CNRO-2003-00063

SUBJECT: Entergy Operations, Inc.  
Requests for Relief from ASME Section XI Volumetric Examination  
Requirements

Arkansas Nuclear One, Unit 1  
Docket No. 50-313  
License No. DPR-51

- Enclosures:
1. Relief Request ANO1-ISI-001
  2. Relief Request ANO1-ISI-002
  3. Relief Request ANO1-ISI-003
  4. Relief Request ANO1-ISI-004

Component ID: 03-008

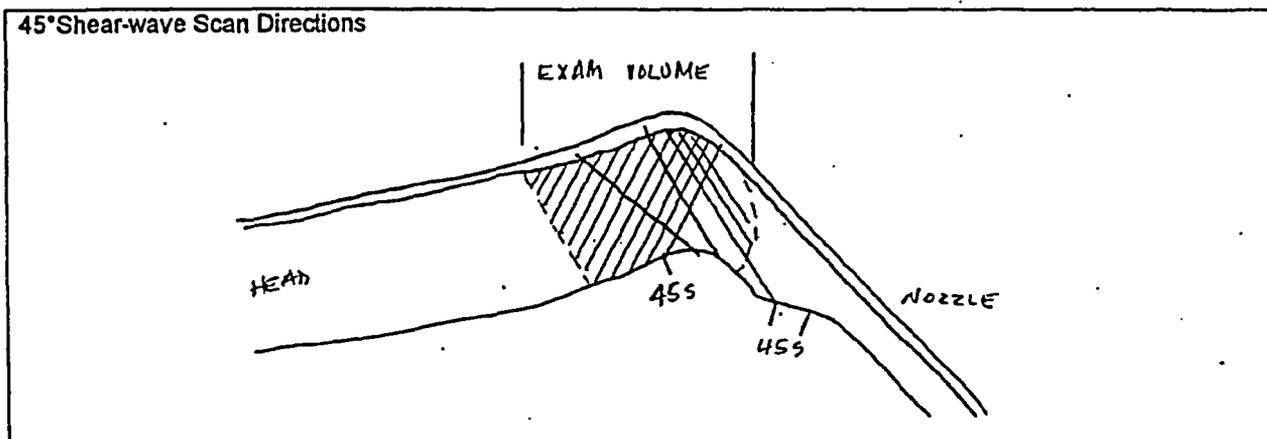
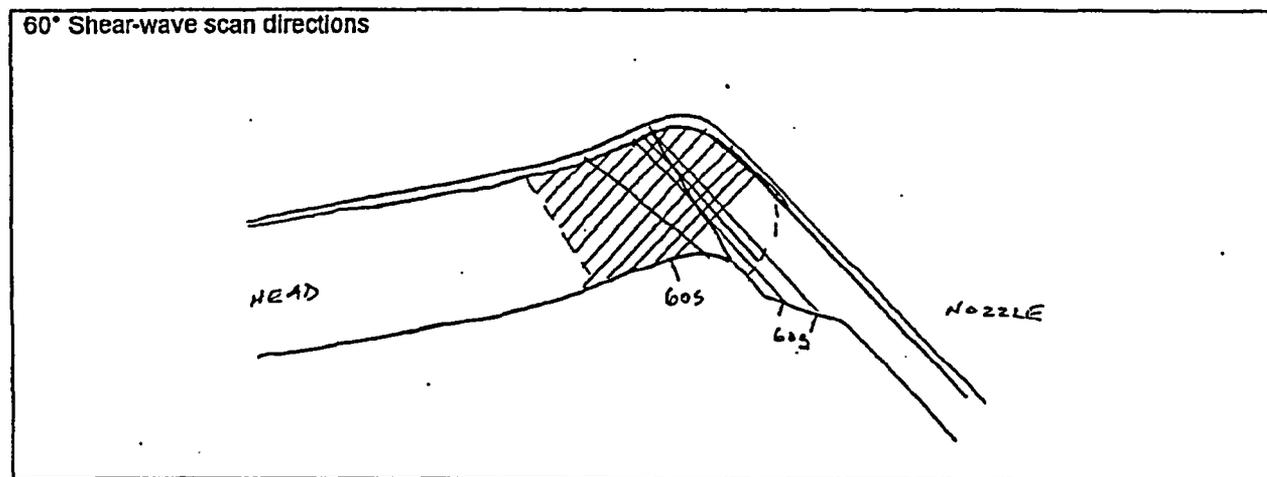
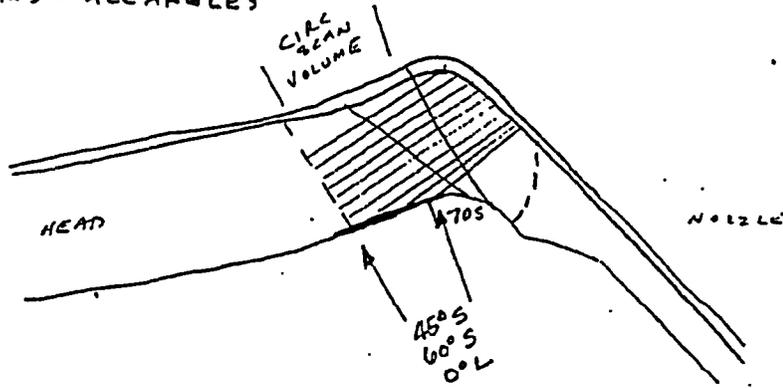
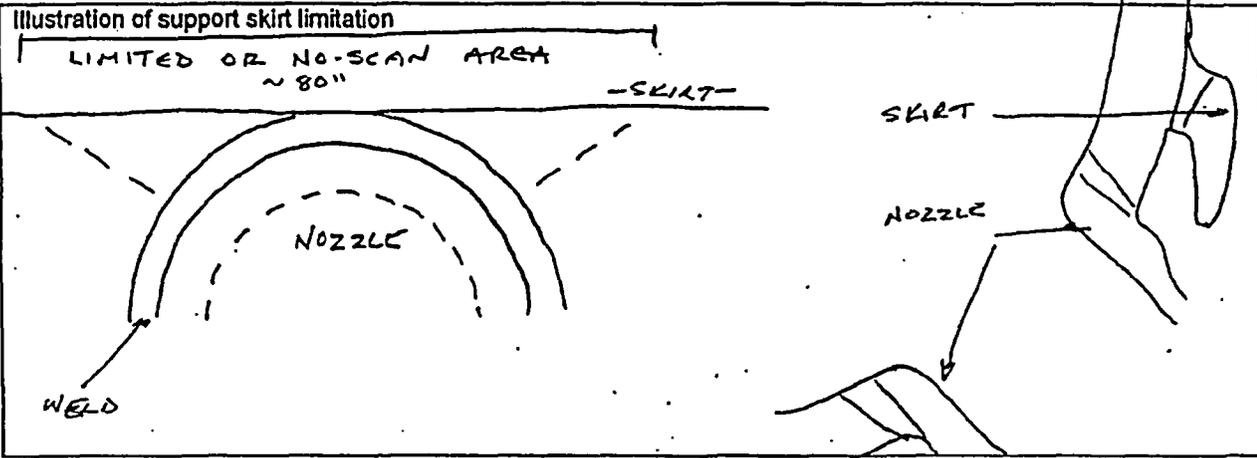
**COMMENTS:** Steam generator cold leg nozzle to lower head. This is primarily a single sided examination. Scans were performed from the nozzle side to supplement coverage with minimal effect. The support skirt prevented scanning around the total circumference of the nozzle. The cumulative coverage estimation includes the code required base metal coverage adjacent to the weld and the factor of multiple angles from multiple directions.

Component ID: 03-009

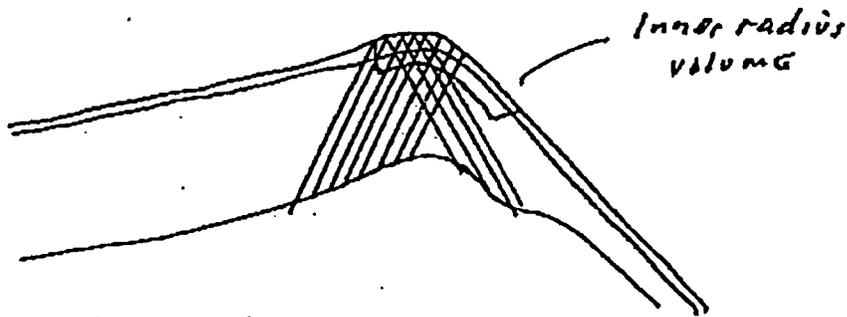
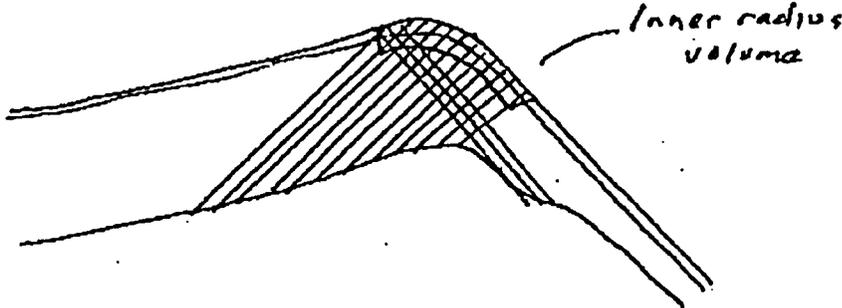
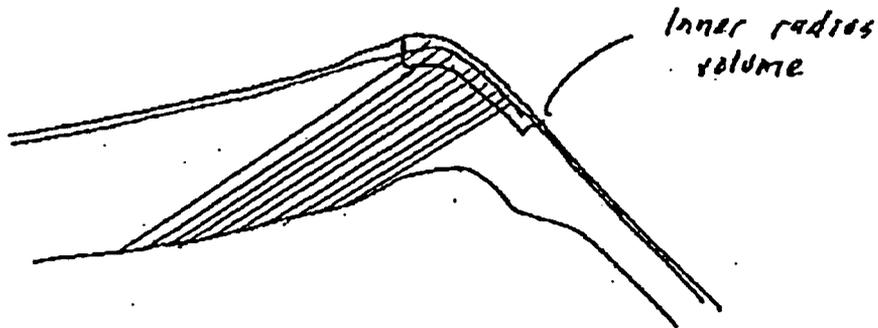
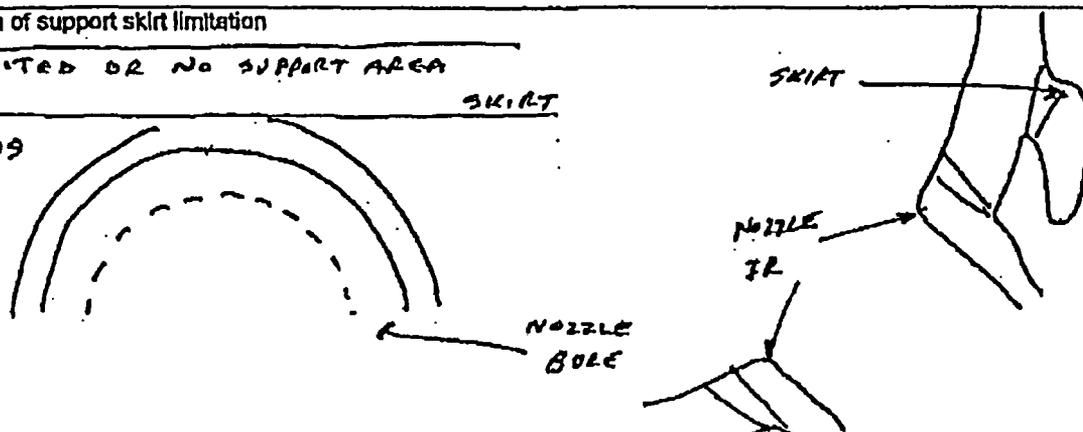
**COMMENTS:** Steam generator cold leg nozzle to lower head. This is primarily a single sided examination. Scans were performed from the nozzle side to supplement coverage with minimal effect. The support skirt prevented scanning around the total circumference of the nozzle. The cumulative coverage estimation includes a summary of the scans with multiple angles from the accessible directions.

Component ID: 05-012

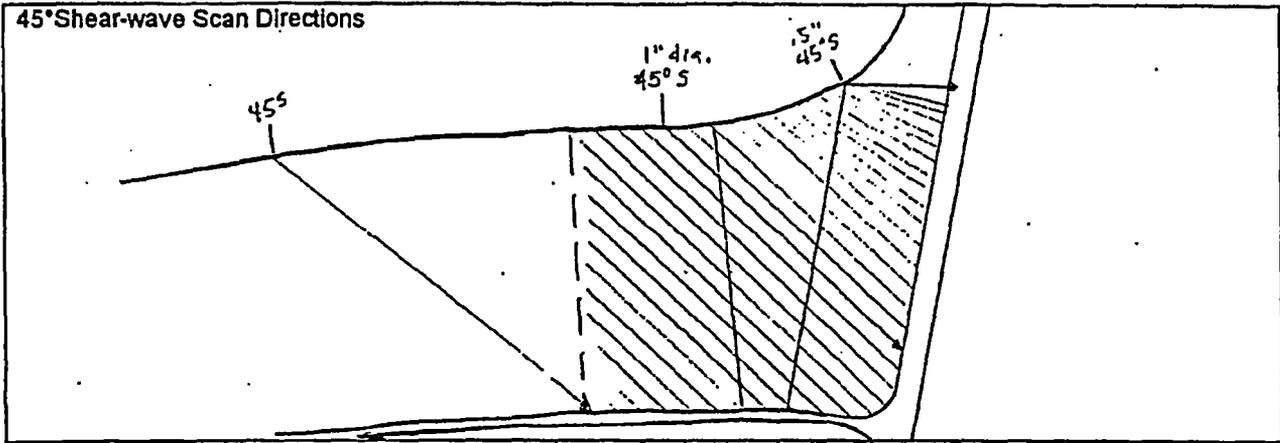
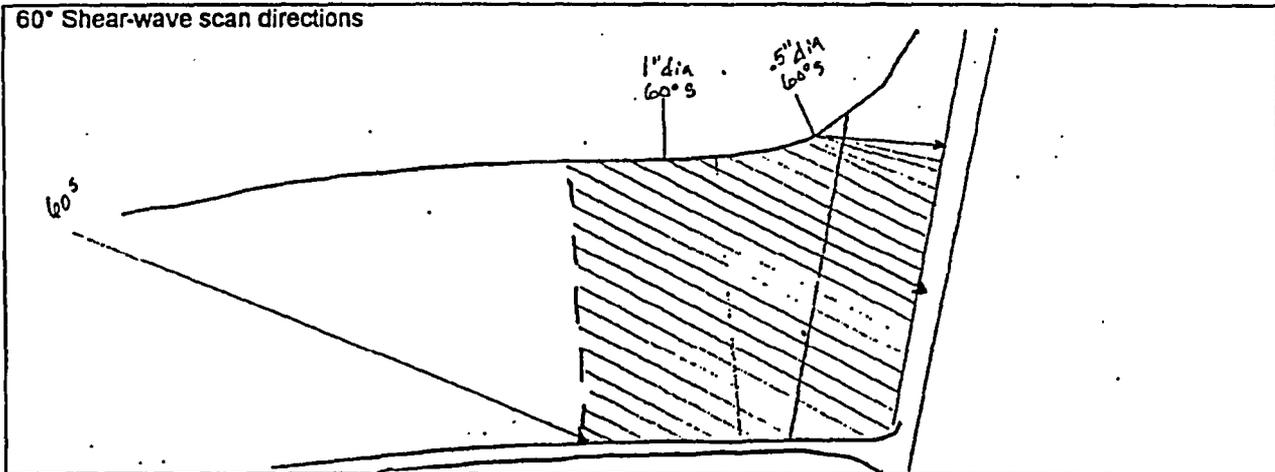
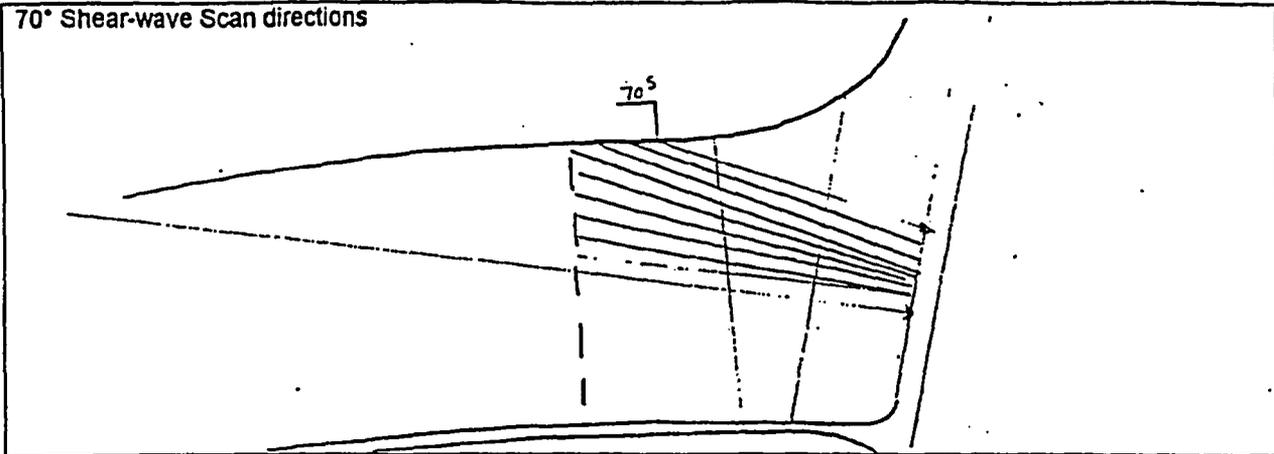
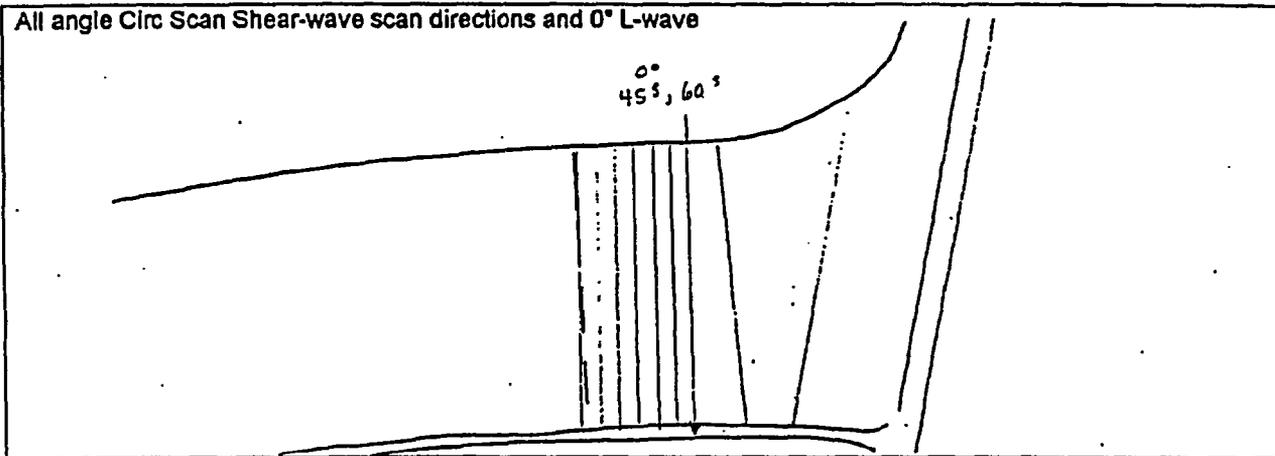
**COMMENTS:** Pressurizer spray nozzle to head weld. This is a single sided examination. The cumulative coverage estimation includes the code required base metal coverage adjacent to the weld and the factor of multiple angles from multiple directions. Coverage illustrations depict added scans with .5" diameter transducers to increase coverage, 1" diameter transducers were used for the primary examination.

Component ID: 05-013

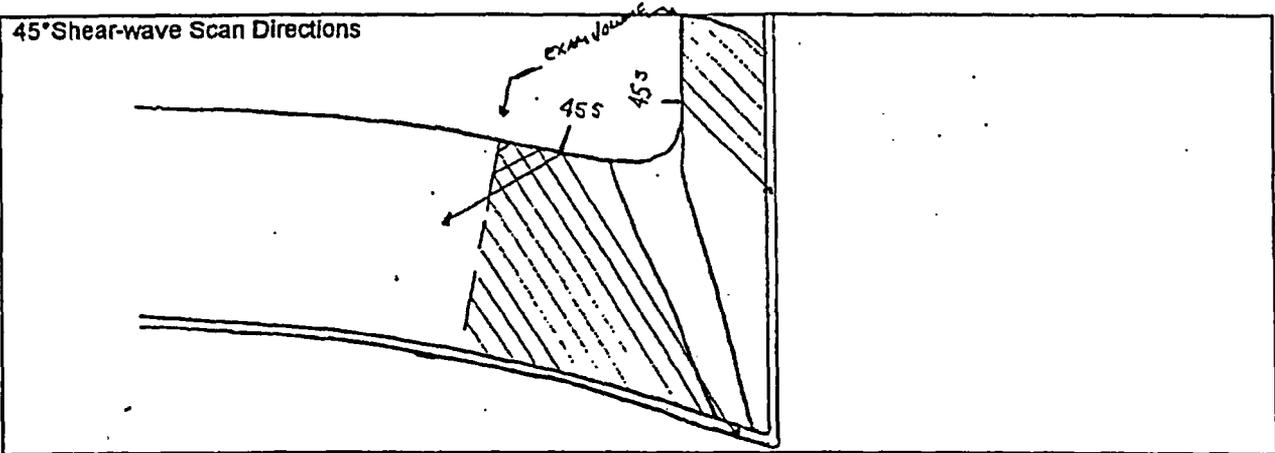
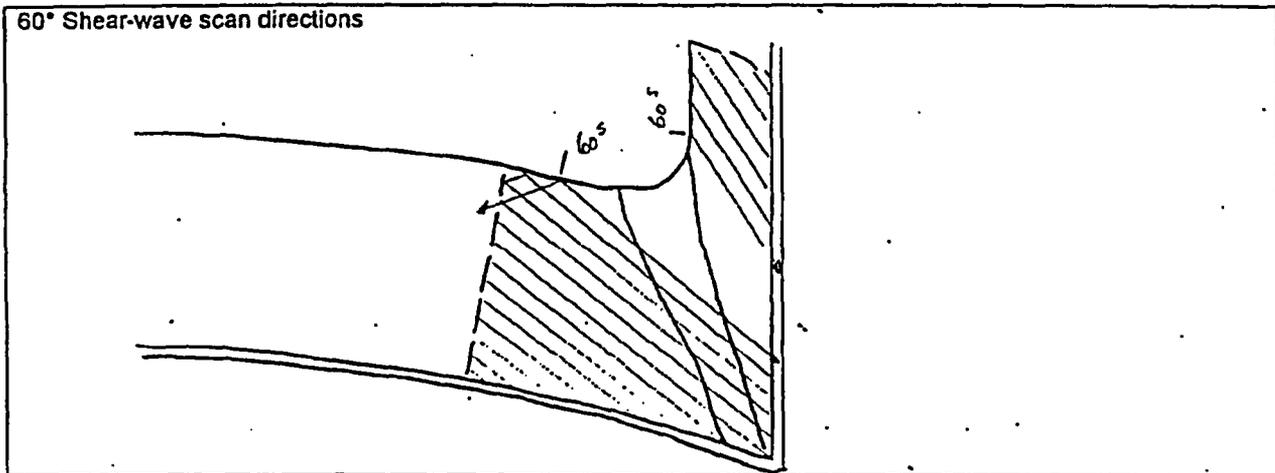
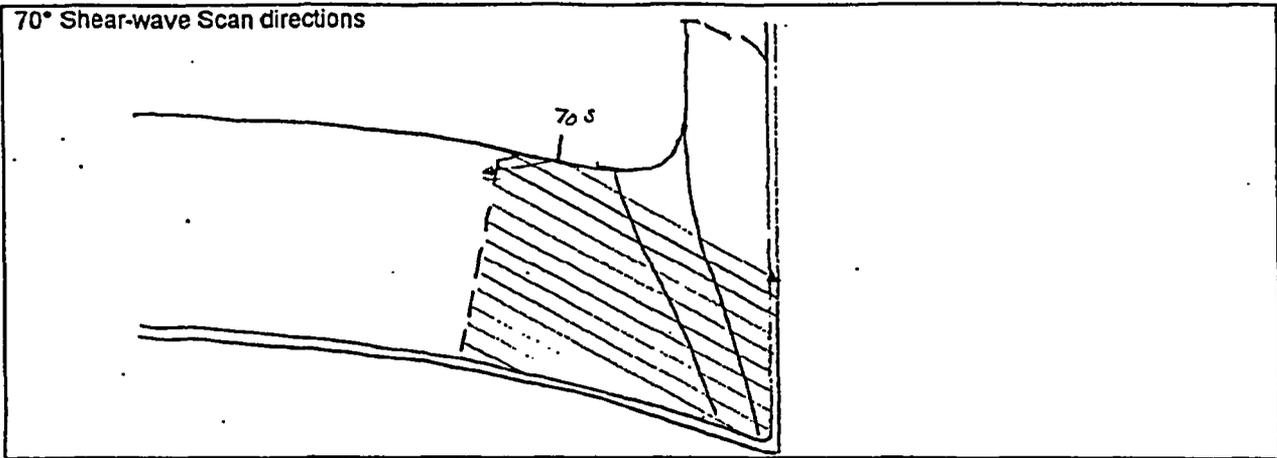
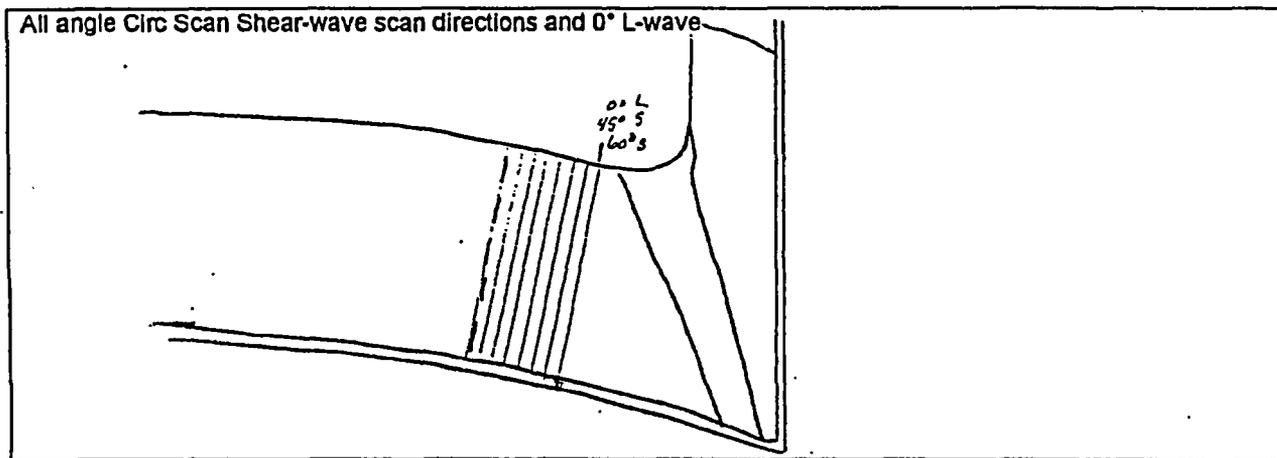
**COMMENTS:** Pressurizer head to safety nozzle. This is primarily a single sided examination. Scans were performed from the nozzle side to supplement coverage with minimal effect. The cumulative coverage estimation includes the code required base metal coverage adjacent to the weld and the factor of multiple angles from multiple directions. Coverage illustrations depict only one location of a complicated nozzle geometry.

Component ID: 24-024

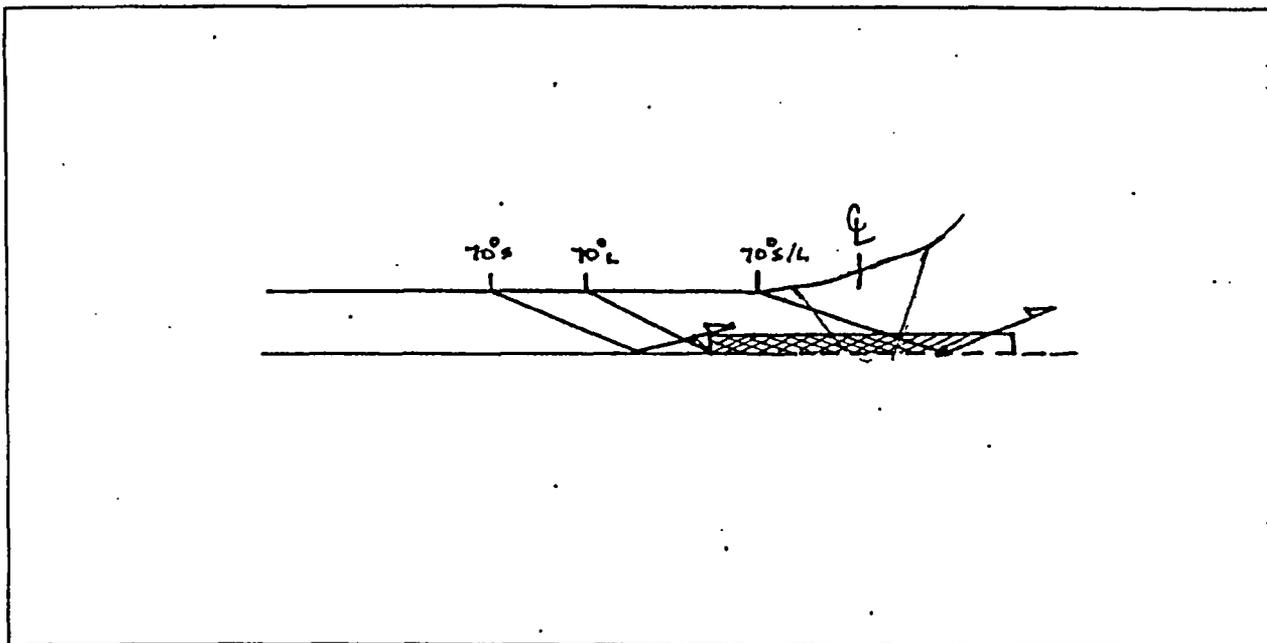
**COMMENTS:** Single side exam due to configuration (pipe to valve). This examination was performed prior to the Section XI, Appendix VIII implementation.

Component ID: 25-031

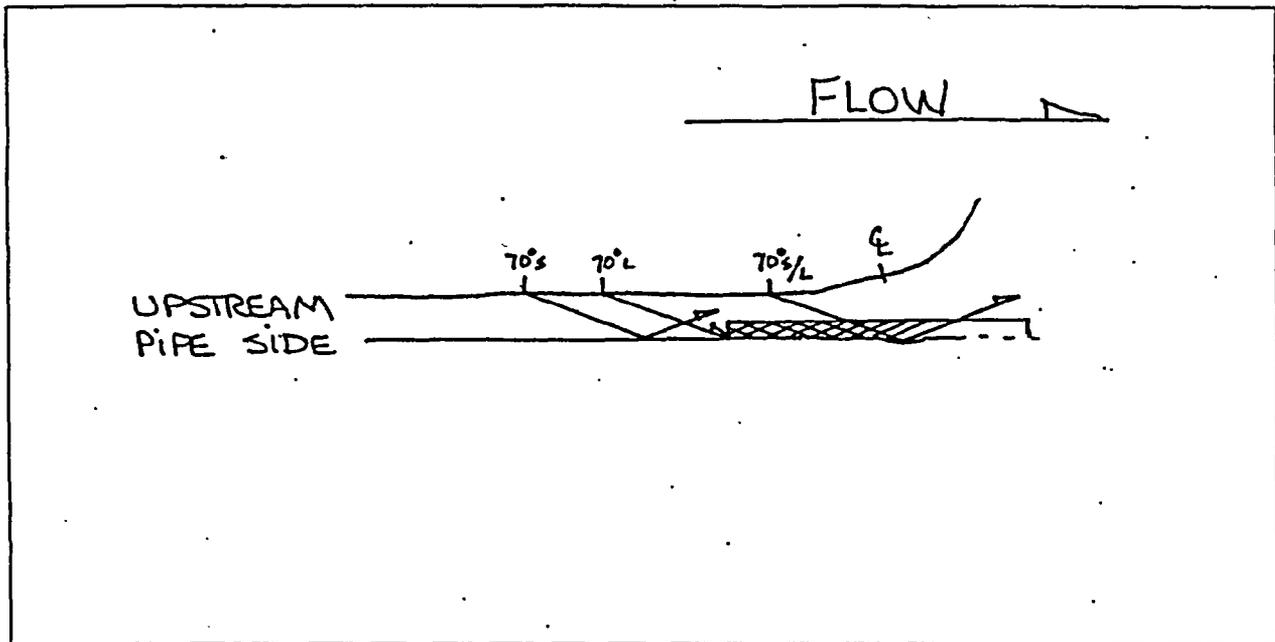
**COMMENTS:** Single side exam due to configuration (pipe to valve). This examination was performed prior to the Section XI, Appendix VIII Implementation.
